PRODUCT UPDATE

FOLLOW UP PRODUCT UPDATE – AgCam Camera

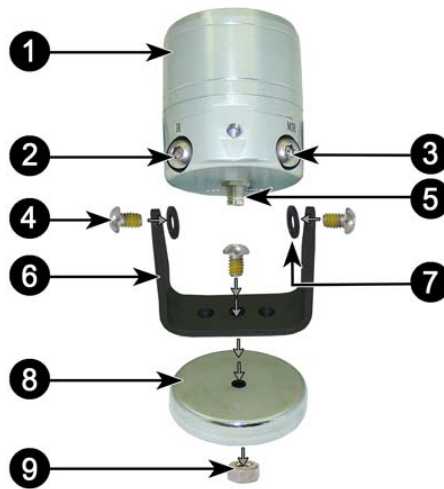
We have completed our changes to the AgCam, making it better than ever. The features we have added are:

- 1) Removable camera tail
- 2) Built in reverse feature
- 3) Built in ON/OFF for IR lights
- 4) More durable mounting bracket
- 5) All new camera board, with enhanced color, brightness, and varying light condition capabilities

- 1) Camera Body
- 2) IR Function Plug
- 3) MIR Fct. Plug
- 4) Retaining Screw (x3)
- 5) Camera tail input
- 6) Camera bracket
- 7) Fiber Washer (x2)
- 8) Magnet
- 9) Magnet Nut

Function plugs are a new feature of the AgCam. There are two on the bottom of each camera near the camera tail. They will look like two additional screws at a slight angle recessed into the camera body. The function plugs utilize a polarized magnet to change camera functionality.

- 1) **IR ON/OFF.** This function plug requires a magnet to allow for the IR LED's to function in low light conditions. If you remove the polarized magnet, the IR LED's will NOT come on.
- 2) **MIR/FOR.** This function requires a magnet to mirror/reverse the camera image to allow for use of the camera as a rear viewing device. **Standard cameras WILL include a MIR magnet.**

On our prior announcement the cameras were not including the MIR magnet, we have since decided to include this option standard.

All AgCam's will now include a fully replaceable 3' camera tail
